Public Service Commission

May 12, 2009

The Reclamation Division has completed a technical review of the application for Revision 25 to Permit KRSB-8802 which proposes to cease mining activities east of Highway 49 and responds to items in our latest midterm review. The following items must be satisfactorily addressed prior to Commission approval:

Figure 1. Changes in watershed size of the intermittent stream controlled by temporary Pond 70 from pre-mine conditions (upper) to post-mine conditions (lower) based on topographic changes proposed with Revision 25 to Permit KRSB-8802.

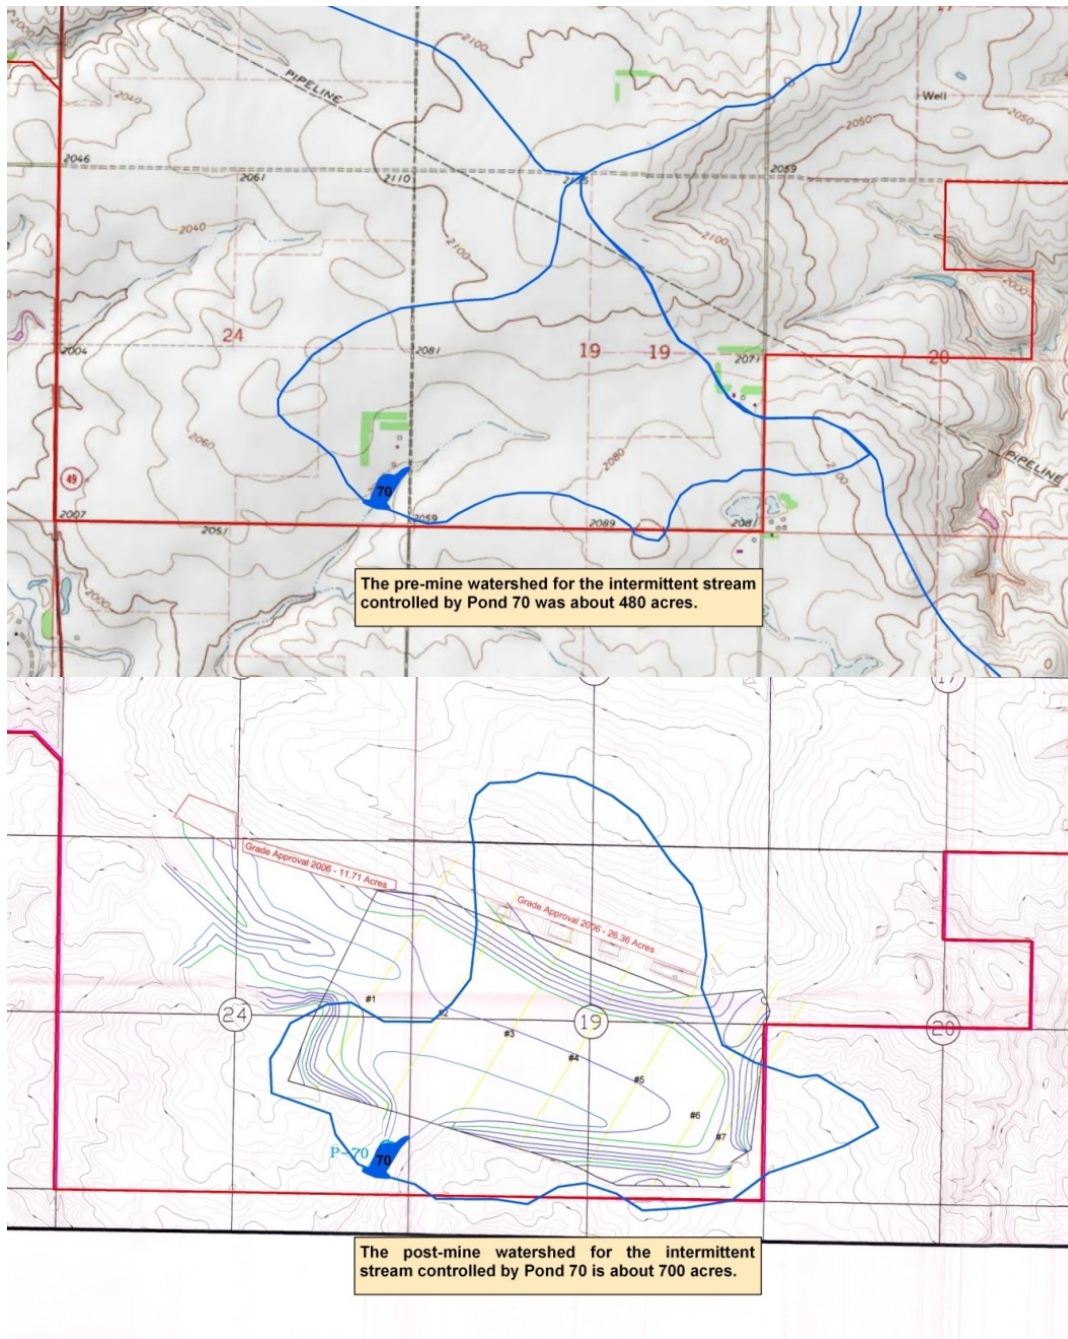
18. With the post-mine watershed of Pond 70 increasing in size (see Figure 1), please review and update the runoff calculations for Pond 70 to ensure that it is adequately sized. This pond is currently designed for a 315 acre watershed. If the pond is no longer capable of storing the runoff from a 10-year, 24-hour precipitation event, or if a spillway has to be modified, please include the appropriate design plans. (DKM)
